Mekong River Commission

Review of the Hydraulic Study for Discharges from the NT2 Regulating Pond and Impacts on the Xe Bang Fai

November 2007

Figure 1 NTPC model general schematization

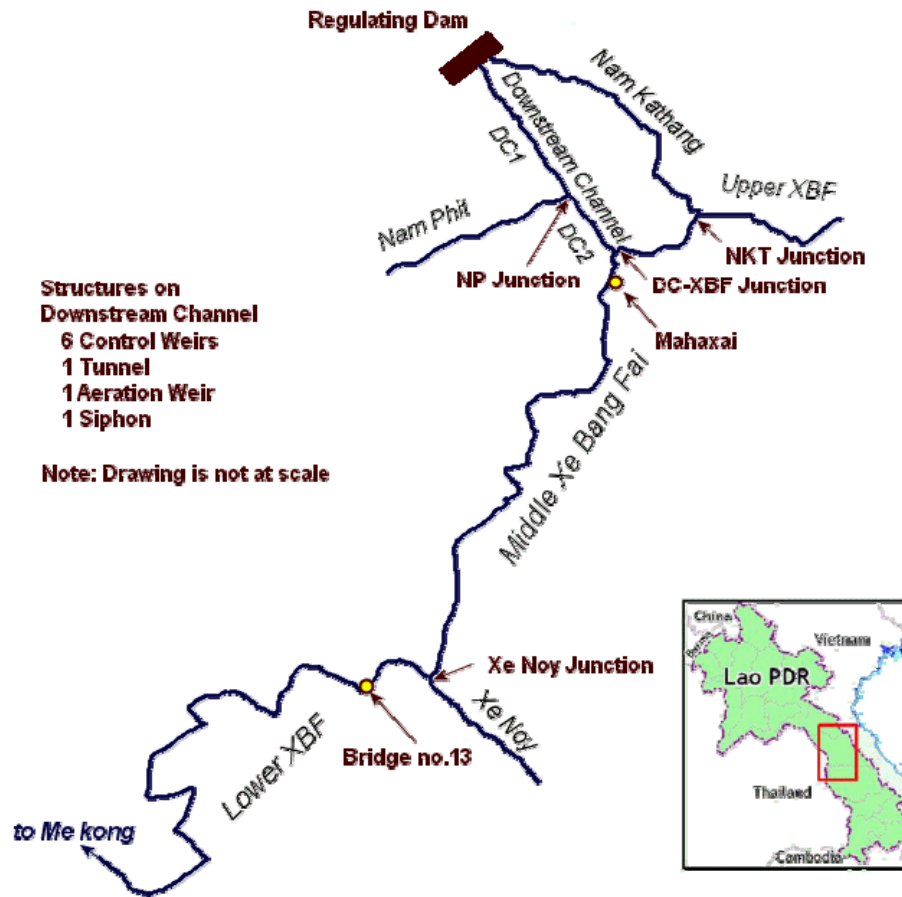
Two tributaries are missing in the schematization, namely Nam Ou La and one upstream Nam Ou La. Their effect on the overall results may be small but could have been included for completeness, as there are at least 6 cross-sections available from Nam Ou La. Including these rivers would also have given results on the fluctuation along these rivers.

There is a problem with the river junctions in the model. There is an almost 10 km gap between the cross-sections from the bridge of Route 13 to the

next upstream cross-section. The junction between Xe Noy and the Xe Bang Fai is situated between these two cross-sections but there is no cross-section at the junction. There is also a gap of more than 10 km between cross-sections downstream and upstream the junction with the DC. Neither of these gaps are included in the model, these reaches are missing from the model setup. These gaps should be included in the model setup, and some (interpolated) cross-sections added. These missing sections will have some, but not significant effect on the final results. A quick check showed that the effect on fluctuation is about 2 cm at Mahaxai and 10 cm at the bridge (fluctuation will decrease if cross-sections are added).

The Consultant checked the effect of the missing 20 km sections from the model on final results by adding interpolated cross-sections. The

fluctuation decreased by about 2 centimetres at Mahaxai, and with about 10 cm at the Bridge. The added length to the modelled river gave a greater dampening of the fluctuation compared to the original model. Thus adding the missing sections to the model decreased the fluctuation reported in the NTPC model report.

Figure 4. Sunday release from regulating pond as a function of Sunday dispatch under optimal conditions. (Source: John F)

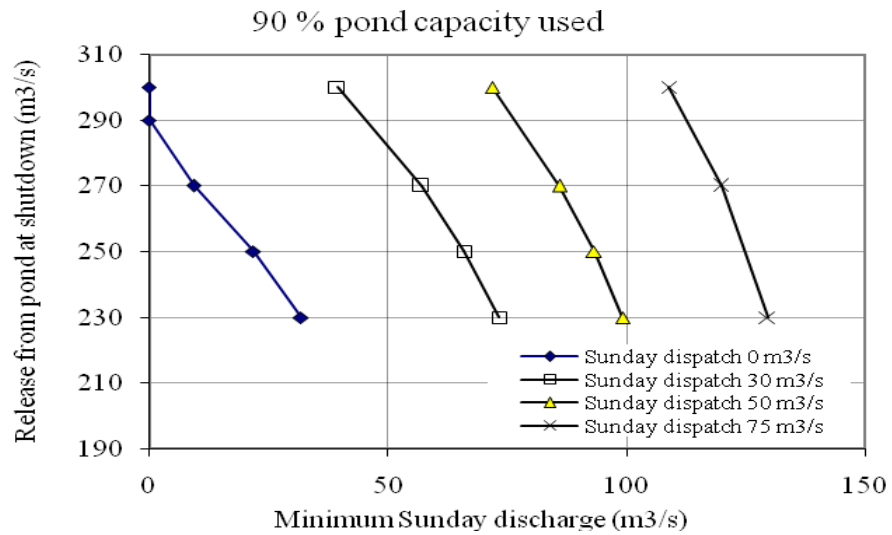
The Consultant made some theoretical calculations of the effect of Sunday dispatch schedules on Sunday releases from the regulating pond. The limit of change in release ($20 \text{ m}^3/\text{s}$ per hour) during the falling stage was taken into account, and it was assumed that 90 % of the 8 Mm^3 volume of the regulating pond could be utilized. It was also assumed that the release to Nam Kathang ($15 \text{ m}^3/\text{s}$) was offset by the same discharge from the EdL turbines. The calculation was then repeated for different values of the Sunday dispatch from the power station.

The results are shown in Figure 4. It can be seen that Sunday dispatch can significantly reduce the weekly fluctuation downstream the regulating pond. It should be noted that the release on the Y-axis is the release at the moment when the turbine discharge is shut down, and does not necessarily

represent the weekday average discharge. Proper planning of operation of the regulating pond may allow lower release rate at shutdown of turbines than what the average weekday release would suggest.

Figure 5. Effect of increasing flow reduction gradient on weekend flow (*Source: Adapted from the NTPC report, NTPC, 2006*)

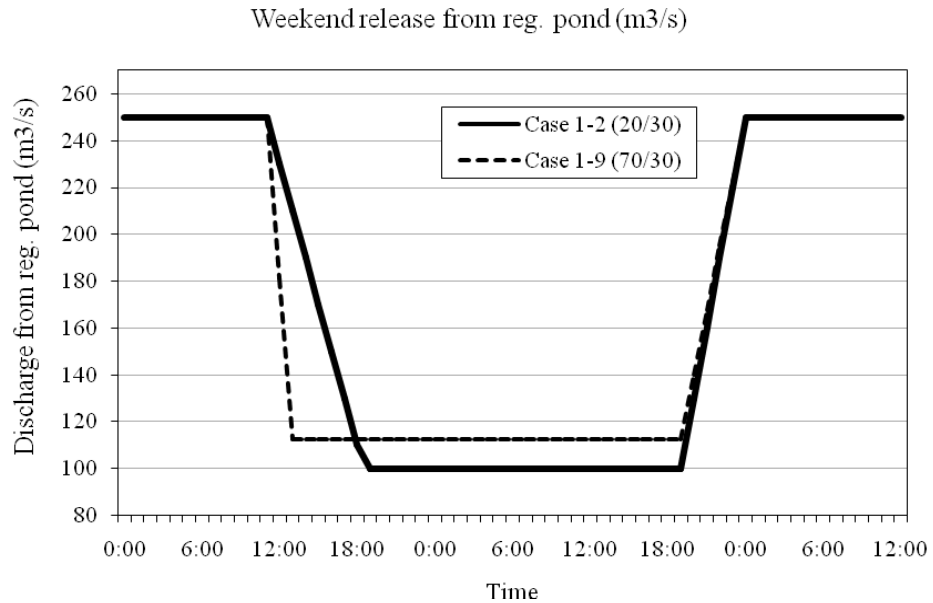
In the NTPC report the scenario 1.9 a faster flow reduction rate from the regulating pond is used, 70 m³/s instead of 20 m³/s as in the base case. This results in a higher weekend flow, as the water saved during the more rapid falling stage can be used to increase the flow on Sunday (Figure 5). Thus the weekly fluctuation will be reduced. However, the benefit of increased flow reduction gradient has to be weighed against increased risk for bank instability and impact on human safety issues.
